Diamond Lincolnia Lincolnia Road Residences

6100 & 6110 Lincolnia Road

Department of Planning and Zoning
Planning Commission Meeting
September 8, 2005

Docket Item #11
DEVELOPMENT SPECIAL USE PERMIT #2004-0010
LINCOLNIA ROAD RESIDENCES

Applicant's Landscape Plan Staff's Recommended Changes

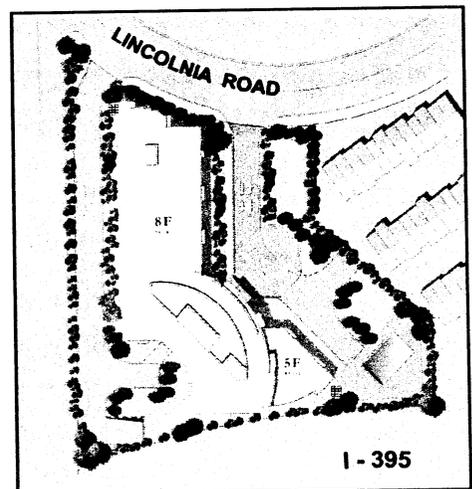
easement for the open space pedestrian connections and the internal courtyard park to enable this space to function as a neighborhood pocket park for neighboring residents. As depicted in the graphic, staff has also added recommendations that will improve the aesthetics, amenities, and functionality of the open space. More specifically, conditions have been included to:

- Provide a public access easement for the internal open space;
- Place sculpture or focal element within the open space;
- Relocate the existing above-grade utilities below grade;
- Create internal sidewalks and pedestrian circulation;
- Use decorative pavers;
- Add pedestrian-scale lighting;

- Provide benches and trash receptacles for the street frontages and internal courtyard;
- Provide bicycle racks; and
- Provide additional landscaping and amenities within the open space.

INITIAL PROPOSAL VS. CURRENT

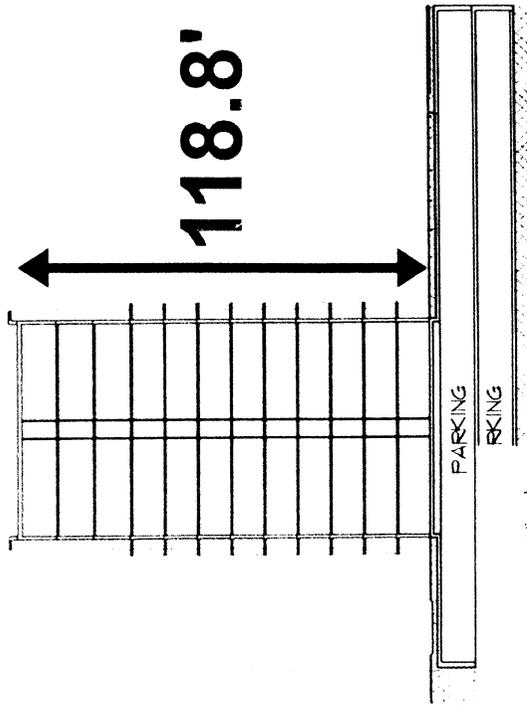
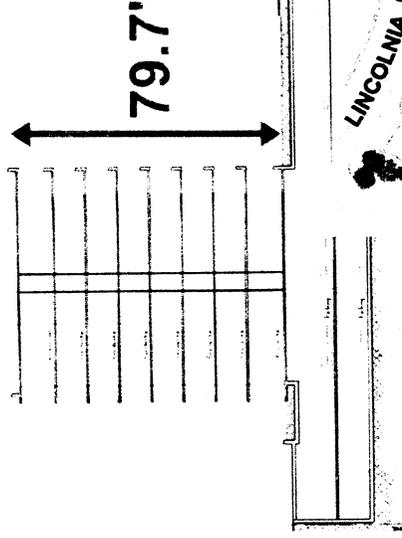
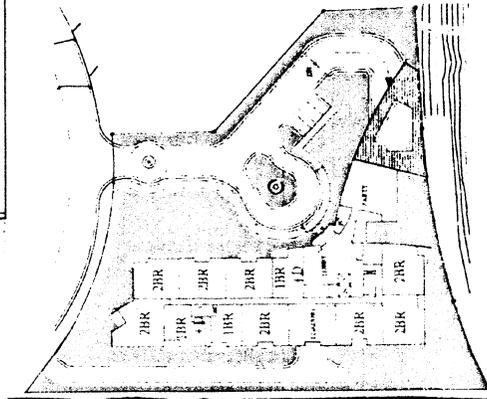
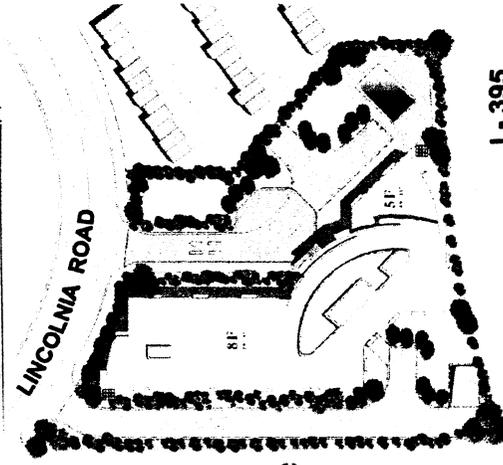
119' tall

Less consolidated open space

All traffic next to townhouses

80' tall

Consolidated open space on east side

Most traffic next to commercial

OPEN SPACE – BUFFER – WALKABILITY:

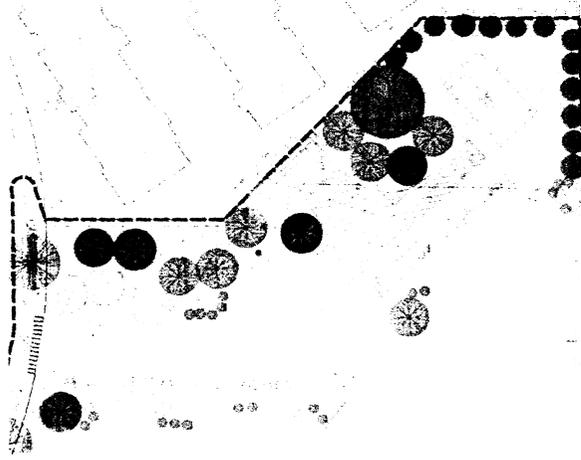
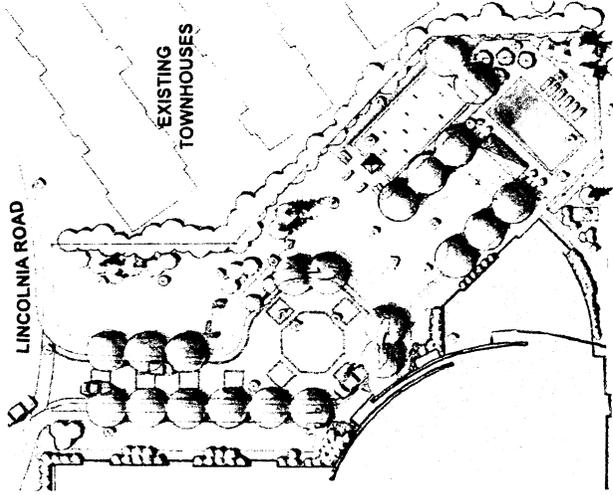
Community wanted setbacks, a landscaped buffer, and publicly open green space
